Model: V85 TT/Travel Euro 4

Subject: incorrect fuel level readings

Photo 2

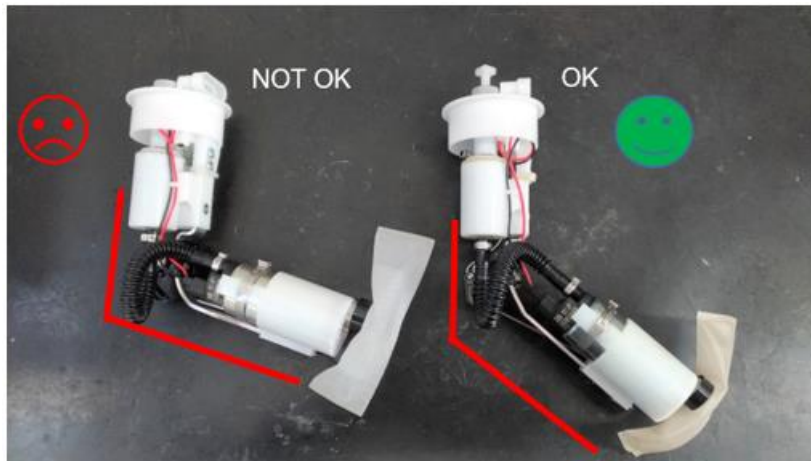
2. **Remove fuel pump and check if fuel level sensor arm is bent (see photo 2).** If the arm is found to be bent, open a request for replacement of the fuel pump under warranty with a new component, attaching photos of the bent arm to the request (if vehicle is still covered by warranty).
